Philco Radio & Television Corp.							
	Model: 511	Chassis:	Year: Pre October 1937				
	Power:	Circuit:	IF:				
	Tubes:	•	·				
	Bands:						
		Resources					
Radio College Of Canada - PHILCO 3							
Riders Volume 9 - CHANGES 9-4							
Riders Volume 8 - PHILCO 8-107

DATA SHEET

Philco 511, 521

Fig. 1. Schematic of the power pack and filter used in Philco Models 511 and 521. The condenser values for each model can be found in Figs. 1 and 3 above.

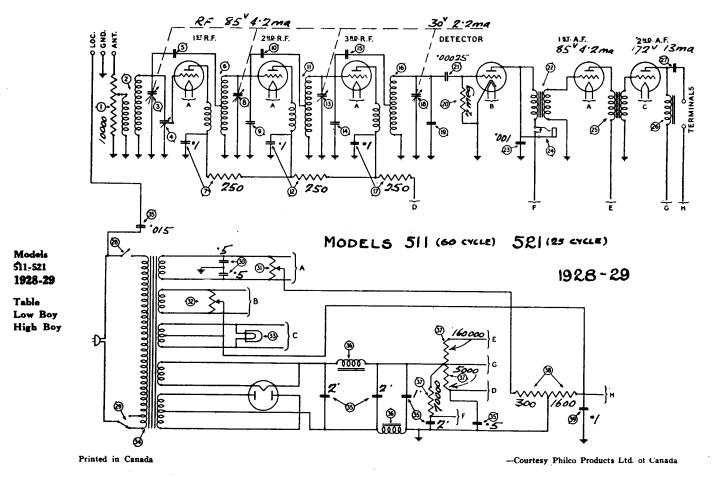
A change in the wiring has been made. The primary of the third r-f transformer instead of going to the left side of the resistor No. 17 now is connected to the other end. Plate voltage for the r-f tubes obtained from the point marked "D" in the voltage divider, No. 37, now is fed in to the resistors Nos. 7, 12, and 17 through

the left end of this combination immediately below the first r-f tube. The primary of this r-f transformer now is connected to the right side of No. 7 in the schematic. In other words, the lead marked "D" at the right end of the three series resistors now is at the left end.

Fig. 1 of the power pack and filter carries various numberings, which correspond to those of Figs. 2 and 3 and show the capacity values of the filter condenser packs No. 35 used for model 511 and 521 respectively. Note that the connections of the 1-mf condenser, 4-5, have been changed from the way they are shown in the schematic on page 8-107. Instead of terminal 4 of No. 35 being connected to terminal 3 of No. 37 it is connected to terminal 1 of No. 35.
